Site Instruction

SI 33

PROJECT : Hampton Manor
PROJECT No : 1136.13
DATE : January 24, 2019

Title: Revised Door Schedule

1:100 A301

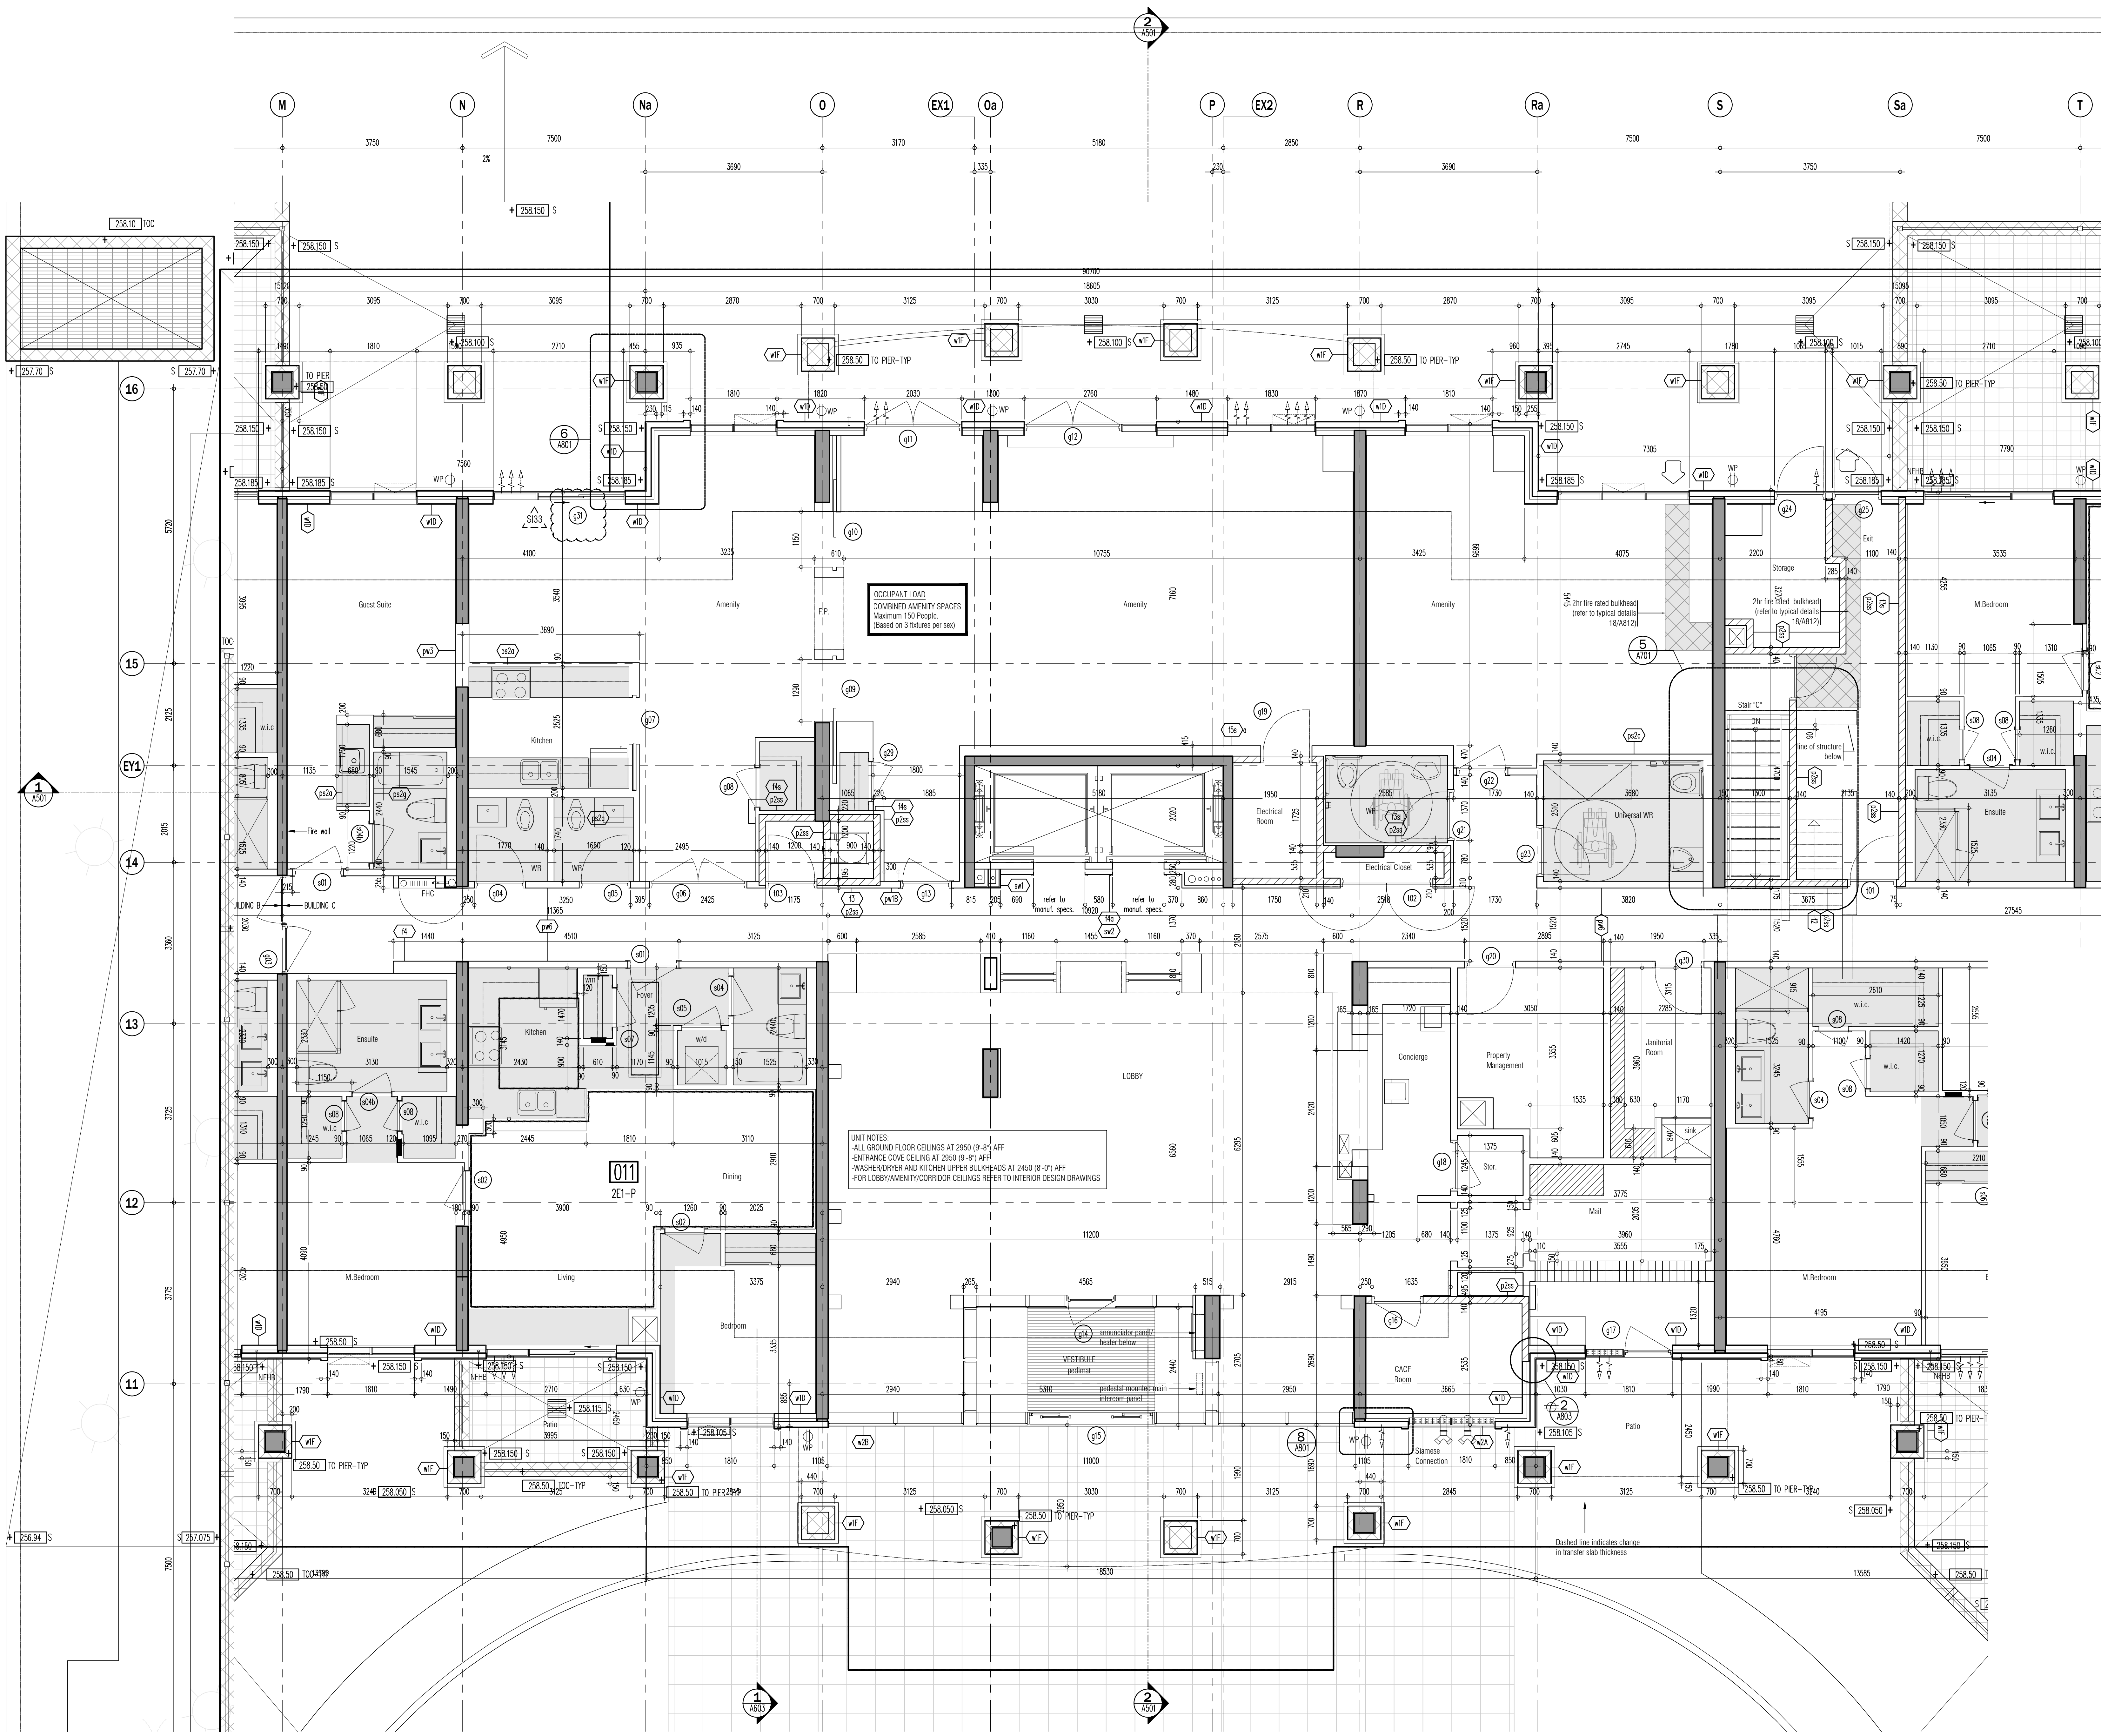
A301, A301b – Ground Floor Plan (Overall & Partial)

- Added door tag “G31”.
